Memorandum

Subject: INFORMATION: Cable Barrier Transitions to W-Beam
Guardrail

Date: MAY - 8 2006

In his May 12 letter to Mr. Richard Powers of my staff, Mr. Brian Smith requested formal Federal Highway Administration acceptance of a design by which your CASS cable barrier is transitioned to a strong-post W-beam or Thrie-beam guardrail.

CASS TO W-BEAM
GUARD RAIL CONNECTION
10/12'6/6'3/CASS-CA/S

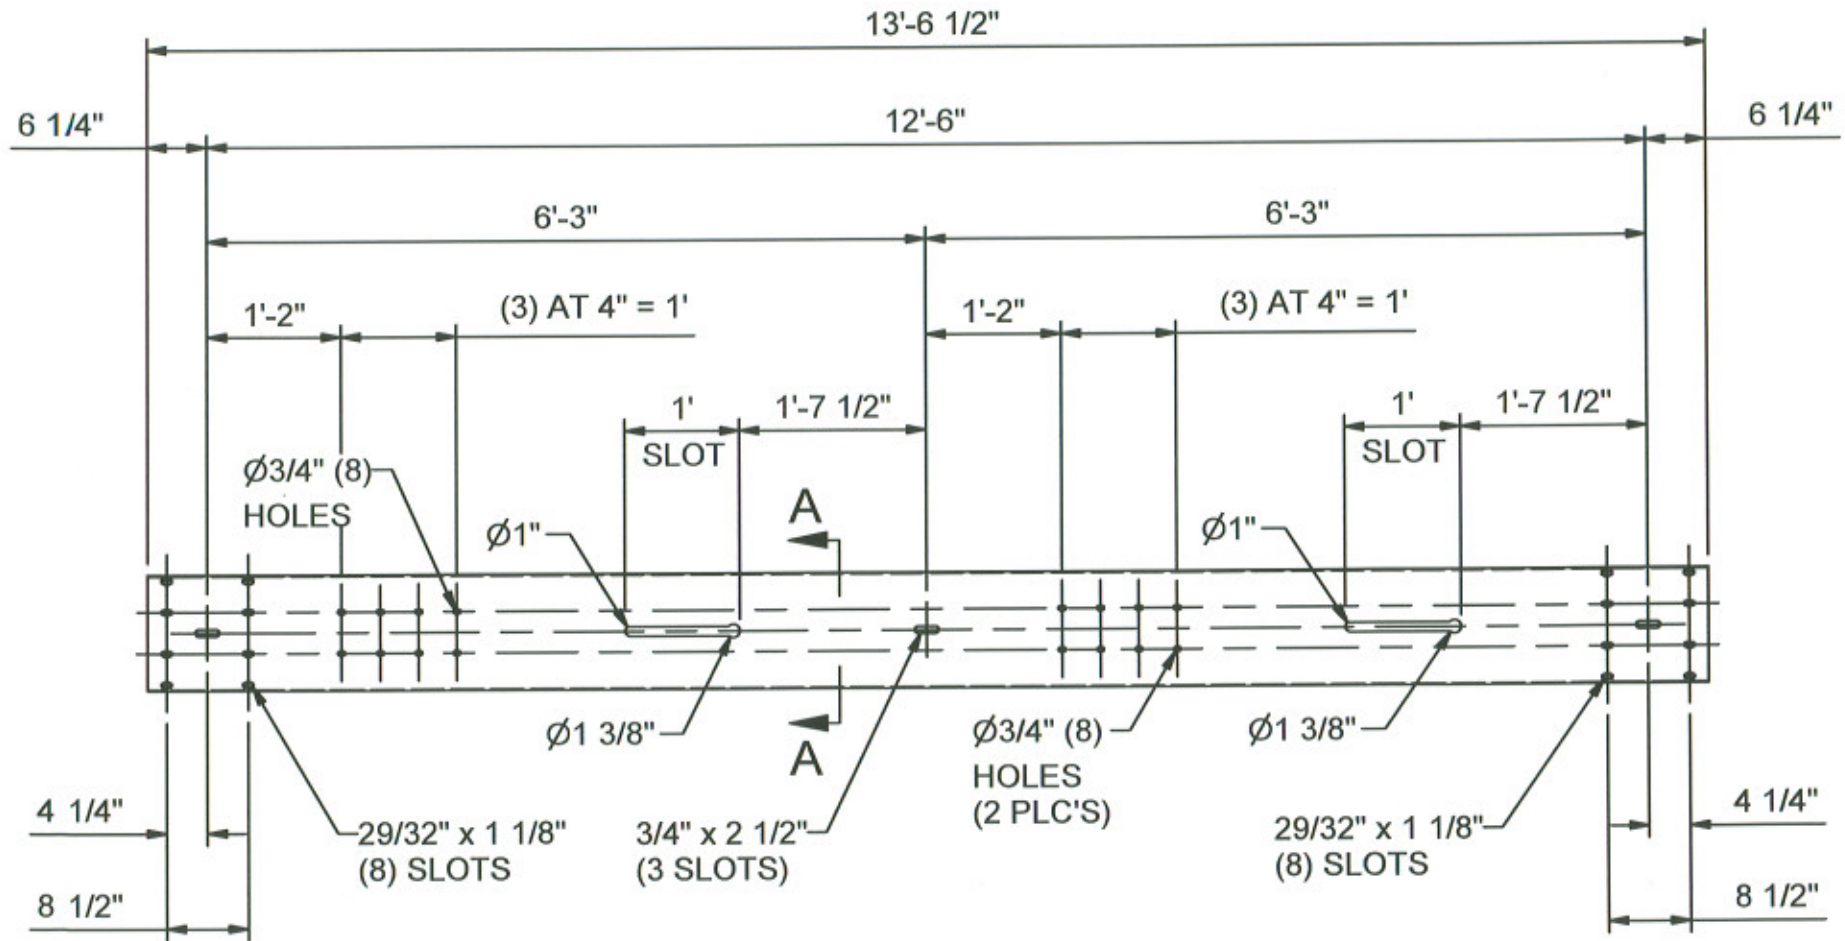
The CASS to W-Beam Transition and CASS to Thrie Beam Transition were submitted for acceptance for use in front of standard W-beam terminals having a 4'0" minimum offset behind the 3-cable prestretched and tensioned CASS system. The transition includes 10-gauge W-beam (either two 12'6"-long or one 25'-long element) or 10-gauge Thrie beam rail elements (one 12'6"-long element and one 6'3"-long transition element) with one-inch wide by 12-inch long slots in the valley of the rail elements. The cables are threaded through the front of the rail and connected to standard cable anchor brackets bolted to the backside of the rail elements. The first CASS post is placed 12'0" from the point where the cables first meet the W-beam or Thrie beam. The transition then consists of 14 CASS posts spaced at 5'0" on center, and then 5 posts spaced on 10'0" centers. The 3 cables, starting at the second post or 17'0" from the tangent W-beam or Thrie beam, taper together to nest into the valley(s) of the W-beam or Thrie beam. Design and layout details are shown in the enclosed drawings.

Previous full-scale crash testing has shown that the high tension and pre-stretched cables of the CASS system result in lower deflections than those seen in the non-tensioned cable barrier. In earlier cable-to-W-beam transition testing with the lower-tensioned generic cable rail, the cable deflection allowed the W-beam terminals to be impacted, resulting in some vehicle instability. With the CASS Transition, it is less likely that the nose of the terminal will be impacted in a typical design impact.

Based on the specific design details noted above, the CASS to W-Beam or Thrie Beam Transitions may be considered acceptable for use on the National Highway System at National Cooperative Highway Research Program Report 350 test level 3 when used in conjunction with

any crashworthy terminal having a minimum 4-foot offset from the cables. Since this design has not been physically tested, field installations should be monitored to verify both its ease of construction and its presumed crashworthiness.

Revisions			WRSF ATTACHMENT TO GUARDRAIL		
No.	Date	By	Date	Drawn By	Scale
1.	8.04.05	MW	7.06.05	Manita Workman	None
2.	8.31.05	MW			
3.					
4.					
5.					
VERSION 8.6					Sheet No.
Dwg. No.				WRSF-05-210a	10 of 11

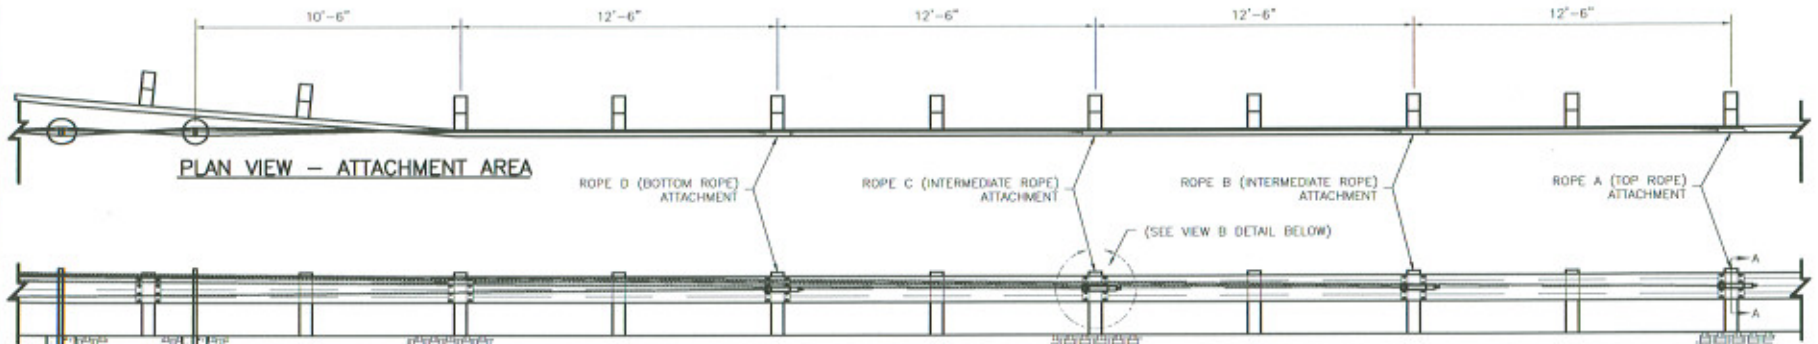
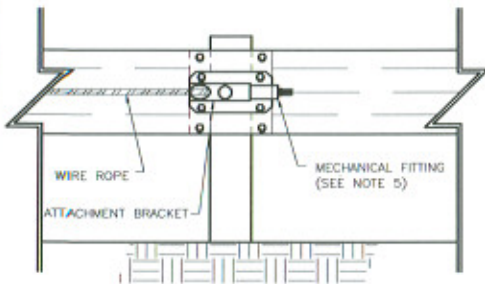
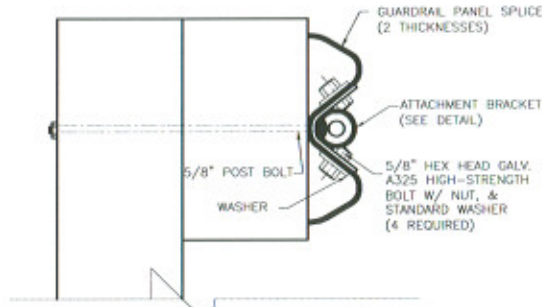
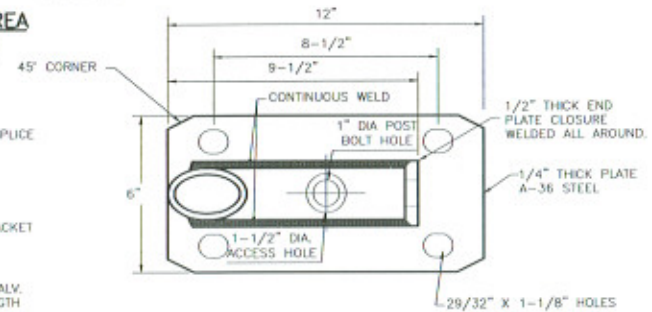
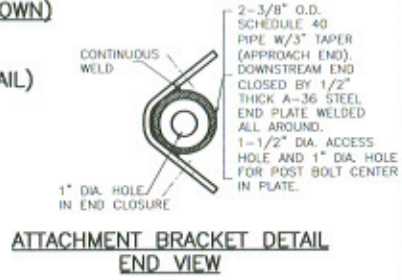
The Brifen WRSF to W-Beam Transition was submitted for acceptance for use in front of standard W-beam terminals having a 4'-0" minimum offset behind the 4-cable pre-stretched and tensioned Brifen system. The 4-cable transition requires four 12-gauge W-beam rail elements 12'-6" long, beginning at the first standard line post in the barrier installation. A unique Brifen attachment bracket is bolted to the rail at each of the first four W-beam rail splice locations and one cable is anchored at each of these brackets. For your 3-cable WRSF, three 12.5' W-beam rail elements and attachment brackets are used. The first WRSF post is placed 10.5' upstream from the first standard guardrail line post at which the lowest cable is connected to the W-beam. The upstream WRSF transition then consists of 16 additional line posts set on 5.25' centers, at which point the standard WRSF post spacing (10.5' or other) begins. Details for the 4-cable, 10.5' post spacing WRSF transition are shown in the enclosed drawing.

Attachment to Thrie-beam guardrail is similar to that shown for W-beam except that, for your 4-cable system, two attachment brackets are located at the first splice and two are located at the second splice. The top and second cables are connected to the brackets in the upper valley (top cable at second splice) and the third and bottom cables are attached to the brackets in the lower valley (bottom cable at first splice). For your 3-cable WRSF the top two cables are attached to the two upper valley brackets (top cable at second splice) and the bottom cable is attached in the lower valley at the first splice location. As with W-beam, all attachments must be at a splice.

Previous full-scale crash testing has shown that the high tension and pre-stretched cables of the Brifen WRSF result in lower deflections than those seen in the lesser-tensioned generic cable barrier. In earlier cable-to-W-beam transition testing with the lower-tensioned generic cable rail, the cable deflection allowed the W-beam terminals to be impacted, resulting in significant vehicle instability. With the Brifen WRSF design, it is less likely that the nose of the terminal will be impacted in a typical design impact. Even so, the use of a lightweight, non-energy absorbing W-beam terminal is suggested to minimize vehicle instability if the terminal is hit.

Based on the specific design details noted above, the Brifen WRSF to W-Beam or Thrie Beam Transitions may be considered acceptable for use on the National Highway System at National Cooperative Highway Research Program Report 350 test level 3 when used in conjunction with a crashworthy terminal having a minimum 4-foot offset from the cables. The design may also be used to connect the WRSF to a weak post W-beam installation when the W-beam is adequately anchored with a crashworthy terminal. Since these transition designs have not been physically tested, field installations should be monitored to verify their presumed crashworthiness.

G.S.I. HIGH TENSION CABLE, LP		
720 W. WINTERGREEN RD., HUTCHINS, TEXAS 75141 (972) 225-1660		
CONTRACTOR:		
SCALE: VARIES	GSI#:	DATE: 10/05/05
REVISED:	CHECKED:	DRAWN: DPD
NESTED PLATE DETAIL FOR HTCB TO MBGF TRANSITION		
TYPE MBGF/HTCB TRANSITION	LAYOUT	1 / 3

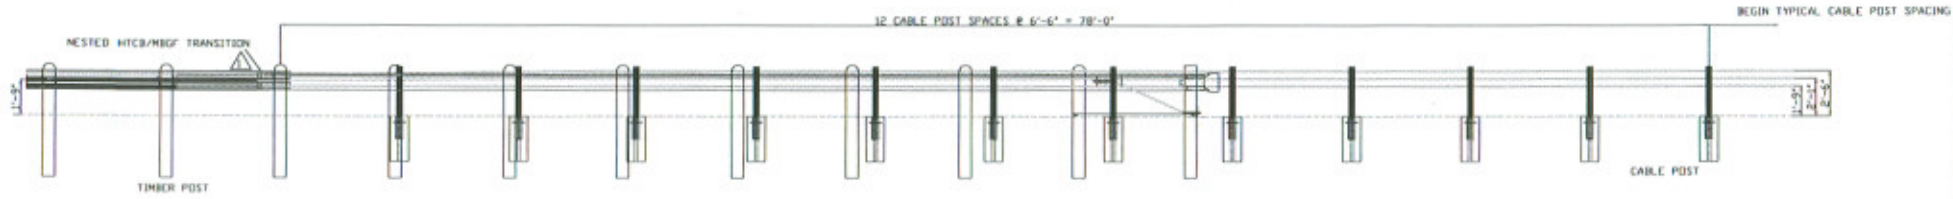
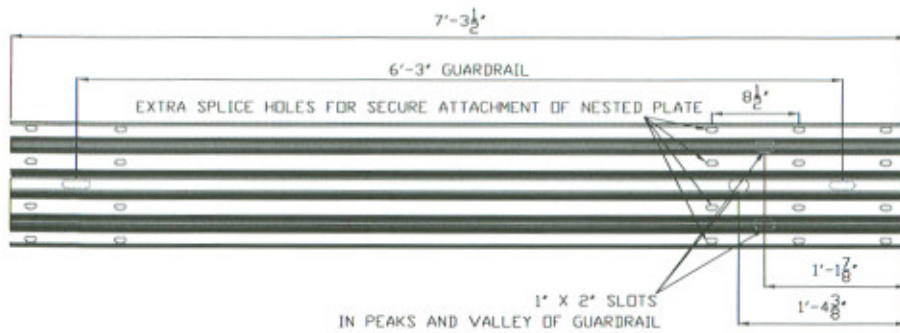
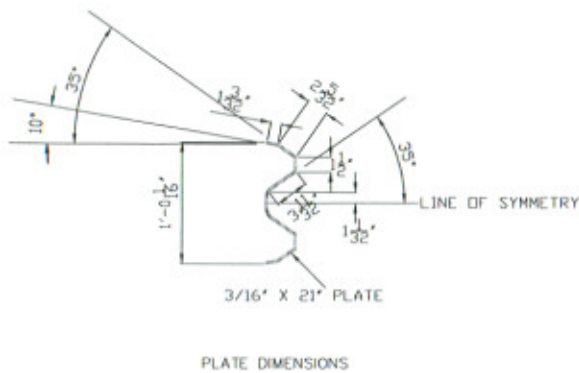
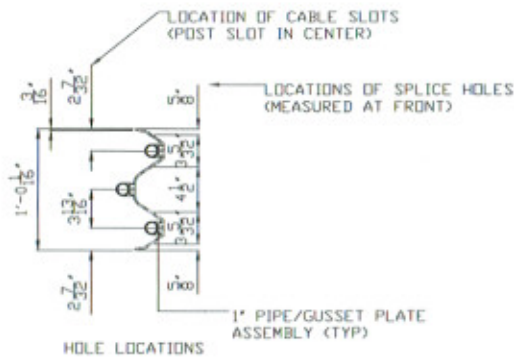
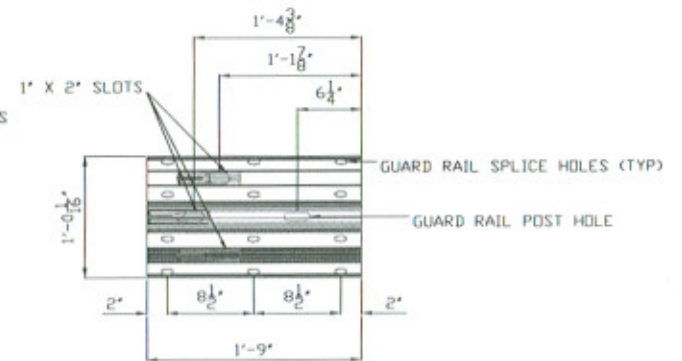
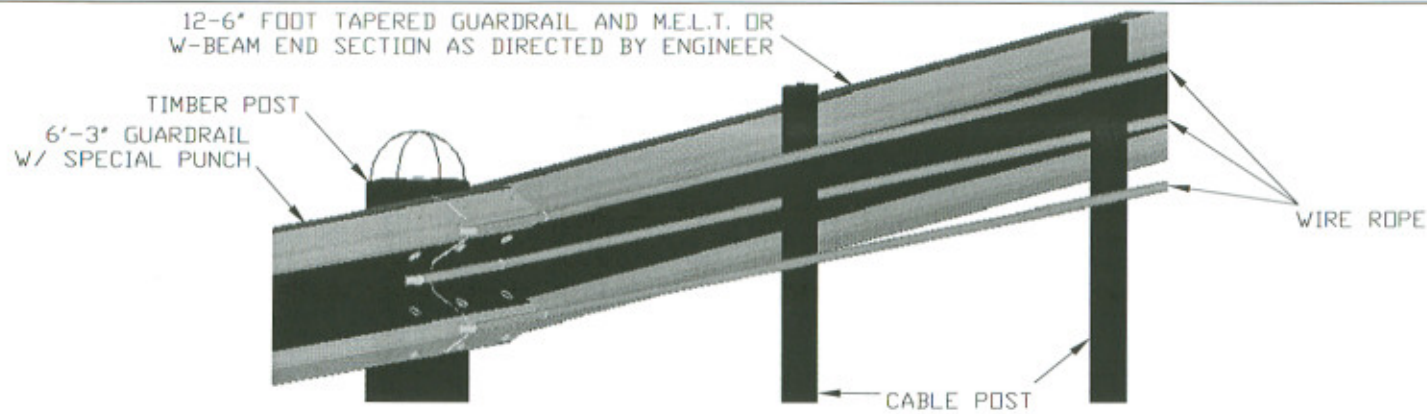
Your transition design is intended for use in conjunction with a W-beam installation that has a standard, crashworthy terminal with a minimum 4'-0" offset from the cable. A unique gusset plate is nested behind and bolted to the back of a special 6 foot-3 inch W-beam panel at the splice located at the first line post. Each cable is threaded through 1-in by 2-in slots in the W-beam panel and connected to the bracket. The first U-channel cable post is placed in line with the barrier proper and 6.5 feet upstream from the first W-beam line post. The transition then consists of 11 additional line posts also set on 6.5 foot centers, at which point your standard post spacing begins. Details for the transition design are shown in the enclosed drawings.

Previous full-scale crash testing has shown that high-tension cable barriers result in lower deflections than those seen in the lesser-tensioned generic cable barrier. In earlier cable-to-W-beam transition testing with the lower-tensioned generic cable rail, the cable deflection allowed the W-beam terminals to be impacted, resulting in significant vehicle instability. With your high-tension design, it is less likely that the nose of the terminal will be impacted in a typical impact. Even so, the use of a lightweight, non-energy absorbing W-beam terminal is suggested to minimize vehicle instability if the terminal is hit.

Based on the specific design details noted above, your proposed transition design is acceptable for use on the National Highway System at National Cooperative Highway Research Program Report 350 test level 3 when used in conjunction with a crashworthy terminal having a

minimum 4-foot offset from the cables. Since this transition design has not been physically tested, field installations should be monitored to verify their presumed crashworthiness.
